ADDENDUM NO. 1

PUBLIC WORKS FACILITY – NATIVE PLANTINGS, WALKING PATH, AND ACCESSIBLE ENTRANCE

Addendum Issued: 02/16/2023

RE: **Addendum #1** for the Public Works Facility – Native Plantings, Walking Path, and Accessible Entrance Project

AREA "C" STORM SEWER AND UTILITY PLAN

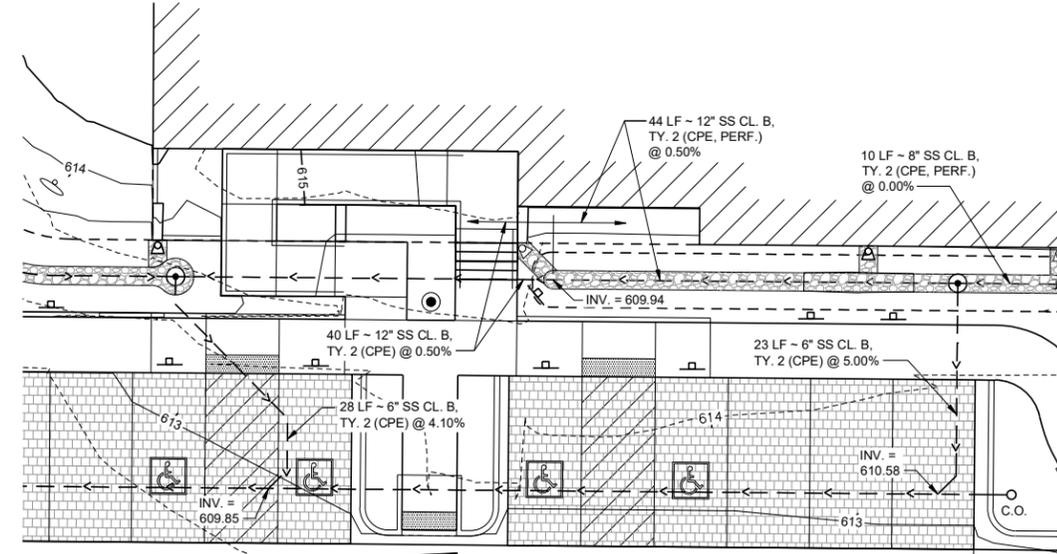
3) Plan sheet #C320 – “Area C” Storm Sewer and Utility Plan

Remove the farthest northwest downspout diffuser and the cobblestone splashpad. There is no downspout in this location.

TRENCH BACKFILL DETAILS - STORM SEWER

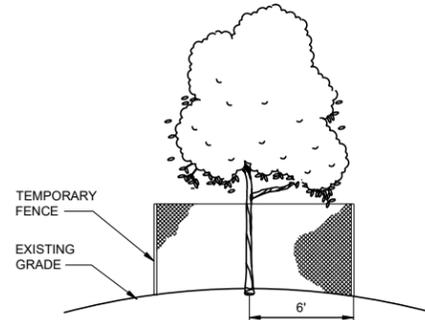
4) Plan sheet #C600 – Erosion Control and Storm Sewer Details

Revise the note on the “Trench Backfill Details – Storm Sewer, CASE I” detail that reads, “CONTROLLED LOW STRENGTH MATERIAL (CLSM) PER IDOT STANDARD SPECIFICATIONS” to instead read as follows:

“TRENCH BACKFILL MATERIAL PER SECTION 208 OF IDOT STANDARD SPECIFICATIONS. TRENCH BACKFILL SHALL BE PLACED IN 12" MAX. LIFTS COMPACTED TO 98% STANDARD
